City of Portland, Oregon
Bureau of Development Services
Land Use Services

NOTICE OF A TYPE II DECISION ON A PROPOSAL IN YOUR NEIGHBORHOOD

CASE FILE NUMBER: LU 10-161705 AD

Proposal: The owners are requesting an Adjustment to reduce the required building setback from 5 feet to 4 feet for a 480 square foot carport and to allow the roof eave of the carport to extend within 3 feet of the east property line. Further, because the carport is attached to the existing garage the applicant is requesting to allow the garage wall to extend within 3 feet of the east property line. Note: Only detached garages may extend to the side property line.

Exhibit C.1

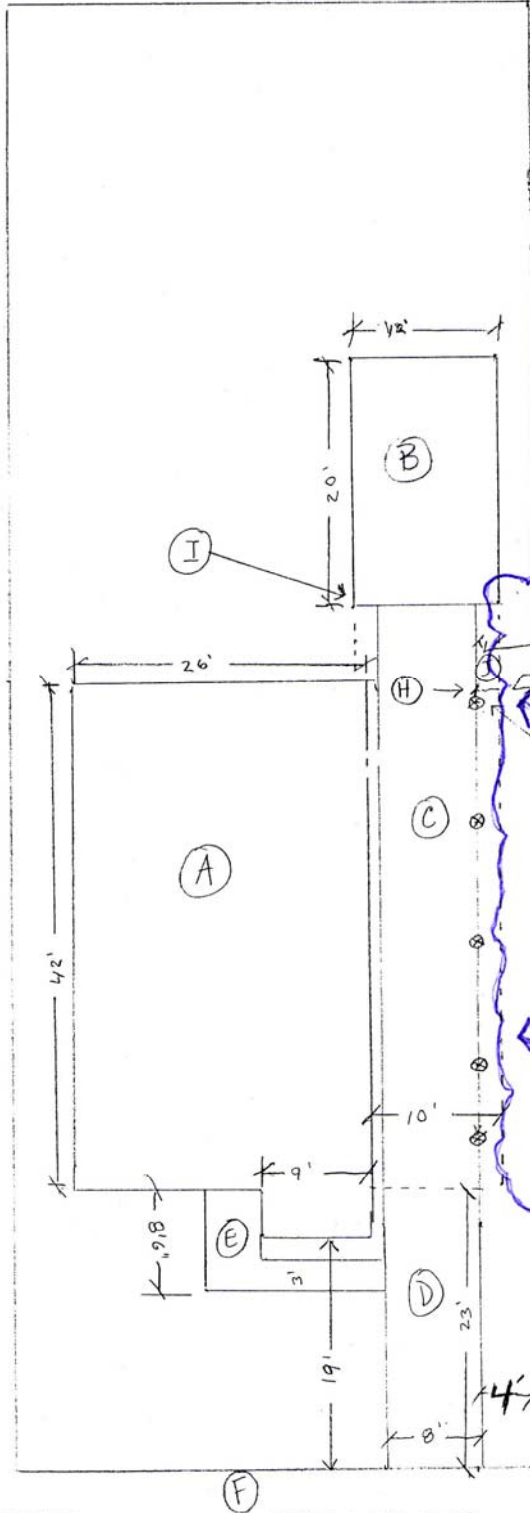
Exterior wall and opening protection – As shown on the site plan, the edge of the eave is located 3’ from the East property line. At this distance, **no** fire rated construction is required. Please be aware that if any of the construction is less than three feet to a property line, one-hour fire-rated construction with no openings is required. ORSC R302.1 (Exhibit E.5)

The requested Adjustment is to reduce the required side building setback from 5 to 4 feet for an attached carport and to allow the roof eave to extend within 3 feet of the side (east) property line. The 4 foot distance is from the carport columns (support structure) to the fence that follows the east property line. The roof extends one foot over the columns.

With a condition that requires the installation of a sight-obscuring fence along the length of the carport, on the interior side of the existing chain link fence, the proposed structure will meet this approval criterion.

Approval of an Adjustment to reduce the require side building setback (33.110.220.B) from 5 feet to 4 feet for a 480 square foot carport and to allow the roof eave of the carport to extend within 3 feet of the east property line, per the approved site plan, Exhibits C.1 signed and dated January 24, 2011, subject to the following conditions:

Required 6-8 ft. tall, sight-obscuring wood fence
